To: T10 Technical Committee
From: Barry Olawsky, HP (barry.olawsky@hp.com) and
Rob Elliott, HP (elliott@hp.com)
Date: 8 November 2004
Subject: T10/04-337r1 SAS-1.1 TCTF Editorial Changes

5.3.11 Transmitter characteristics

Figure 51 — Compliance interconnect TCTF test load

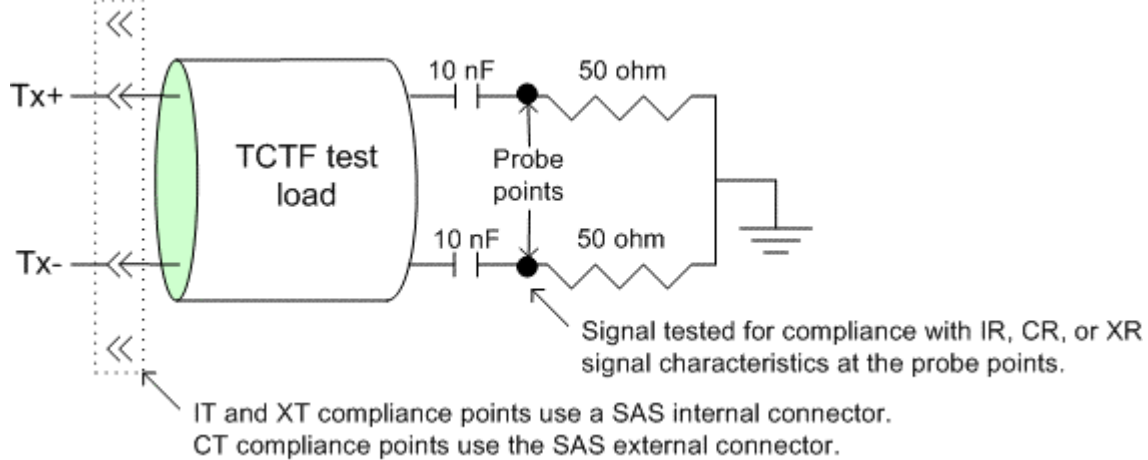
Text added to zero-length test load description mentioning that the transmitter compliance point signal characteristics must be met there. That rule is already stated in 5.3.4. Added text next to the probe points in the test load figures showing which signal characteristics are tested there.

Compliance with the TCTF test load requirement shall be determined by measuring the signal produced by the transmitter through a physical compliance interconnect TCTF test load attached to the transmitter compliance point (i.e., IT, CT, or XT) as shown in figure 51.

Figure 51 shows the ~~compliance interconnect TCTF~~ test load.

Figure 52 — Zero-length test load

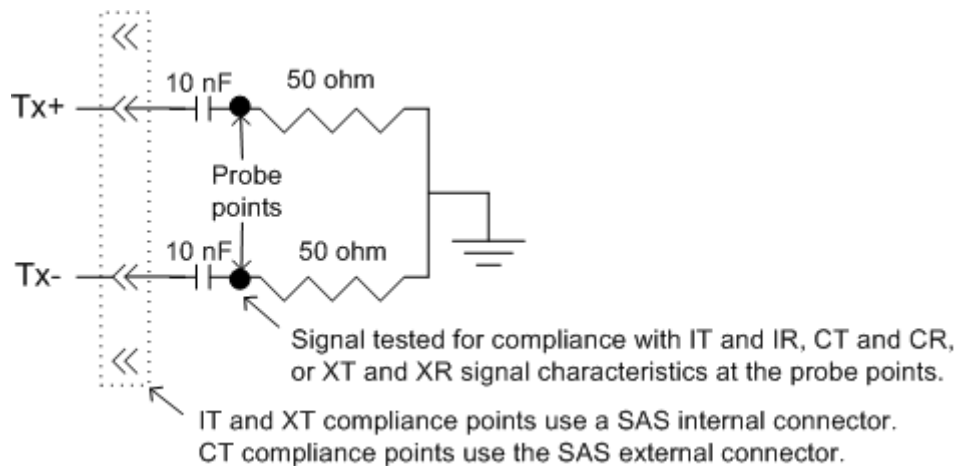
Compliance with the zero-length test load requirement shall be determined by ~~measurement made across measuring the signal produced by the transmitter through~~ a load equivalent to the zero-length load ~~attached to the transmitter compliance point (i.e., IT, CT, or XT) as~~ shown in figure 52.

Figure 52 shows the zero-length test load.

Figure 53 — ISI loss example TCTF S_{21} and ISI loss requirements at 3,0 Gbps

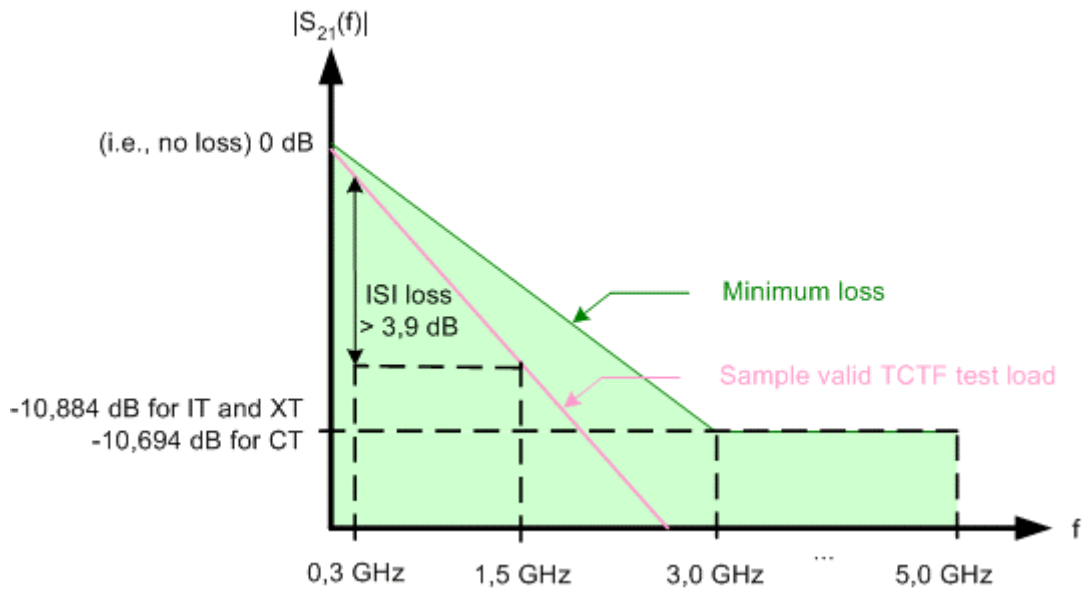
The S21 equations and introductory text is rephrased so \leq can be used. They are now phrased as describing the S21 of a (valid) TCTF test load. There are many possible TCTF test loads - any that fit in the \leq region. The graphs are shaded reflecting this.

Figure 53 shows ~~an ISI loss example the allowable $|S_{21}(f)|$ and minimum ISI loss of a TCTF test load and the $|S_{21}(f)|$ of a sample TCTF test load~~ at 3,0 Gbps.

[Note to editor – Generate separate graphs for IT/XT and CT since the CT line is not straight.]

Figure 54 — ISI loss example TCTF S_{21} and ISI loss requirements at 1,5 Gbps

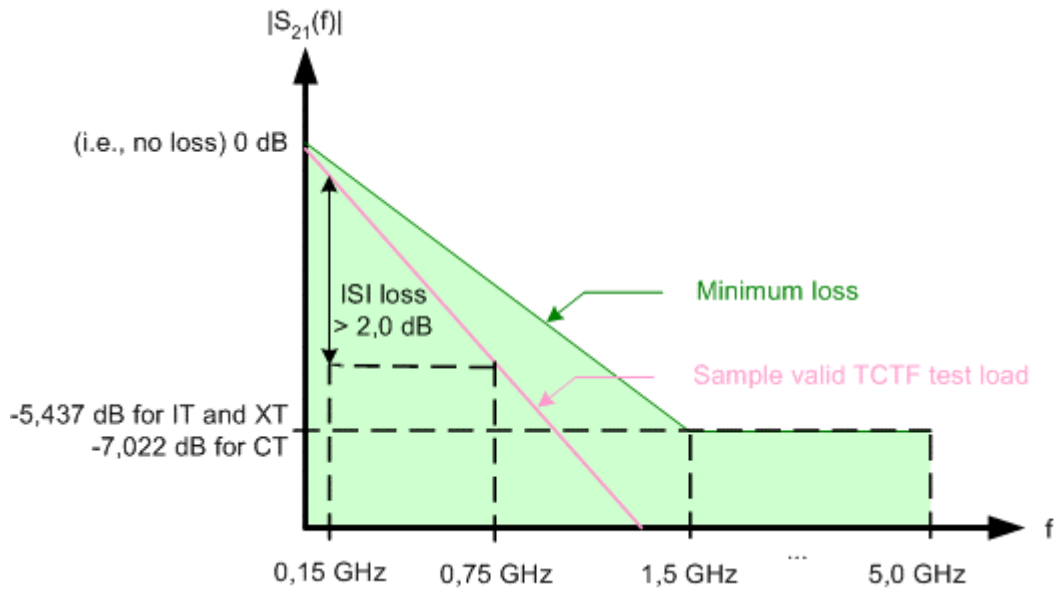
Figure 54 shows an ISI loss example the allowable $|S_{21}(f)|$ and minimum ISI loss of a TCTF test load and the $|S_{21}(f)|$ of a sample TCTF test load at 1,5 Gbps.
